Grand Traverse Commons
Joint City of Traverse City/Garfield Township Planning Commission

DATE:	For February 3, 2016 JPC Meeting
TO:	Joint Planning Commission
FROM:	Township / City Staff
RE:	Zoning Ordinance Discussion

Medical District
Sub-District 3 (M-3)

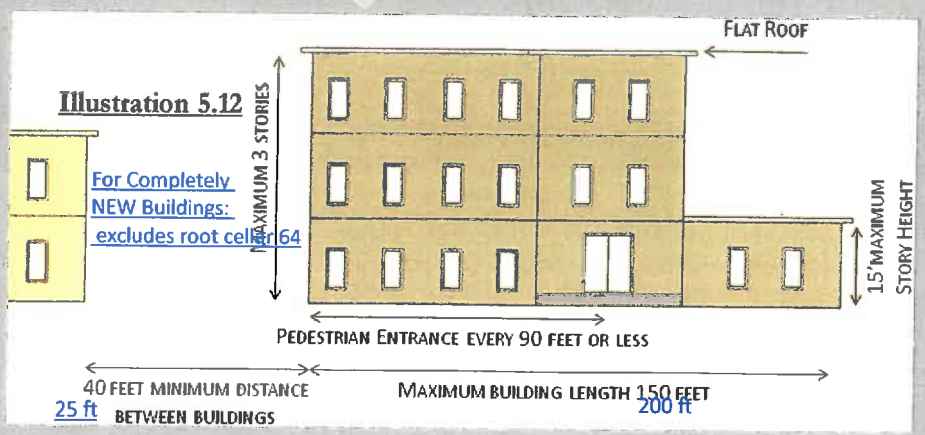
~~200 ft~~Rationale? For existing or new construction? Use 65 as baseline.

Illustration 5.15

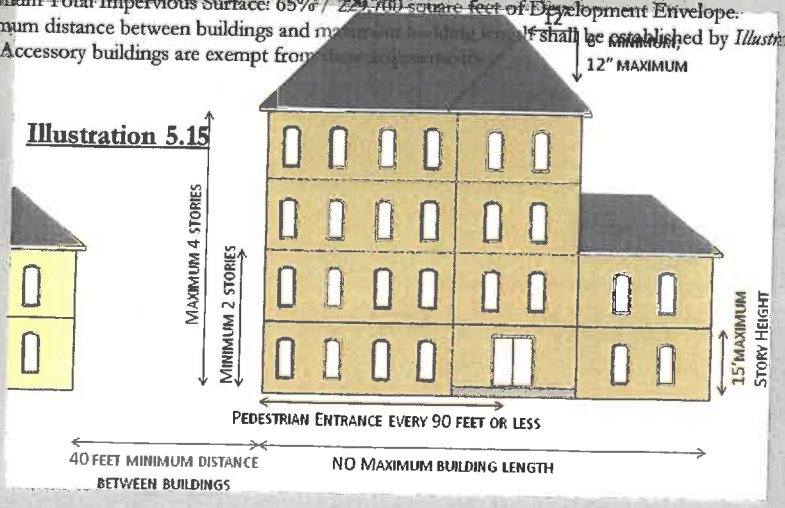
MUST ALLOW FOR REPLACEMENT OF OLD CENTER MAIN-TYPE STRUCTURE (5 stories?)
Agree, but was it 5 stories?
Agree if so.
